SERVICE BULLETIN #1119

MODEL 99

SUBJECT SHIM (TRANSMISSION TO CRANKCASE COVER)

This Bulletin is a Revision of Service Bulletin #224

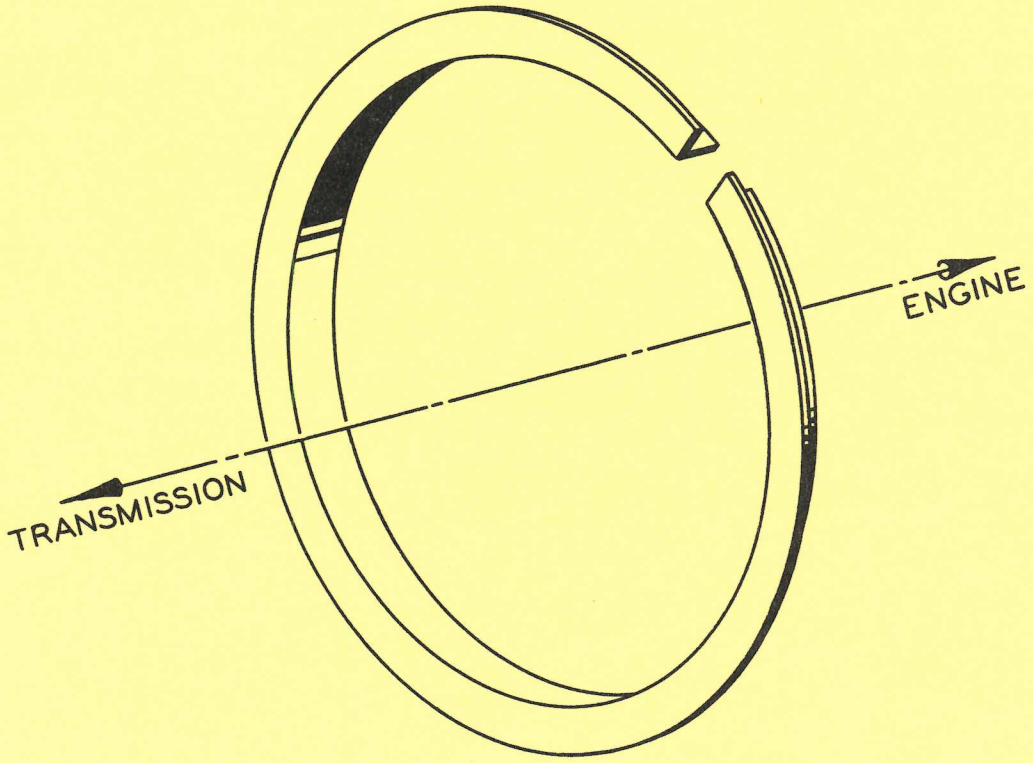
To provide longer service life for the clutch assembly, install a Transmission Shim, P/N 24790, between the transmission assembly and the crankcase cover. The mating surfaces on the transmission assembly and the crankcase cover are subject to wear. If the mating surface wear becomes excessive, causing misalignment, cutting will be more difficult and early clutch failure can result.

Installation of the Transmission Shim, P/N 24790, will correct the alignment of the two mating surfaces if they are loose or worn.
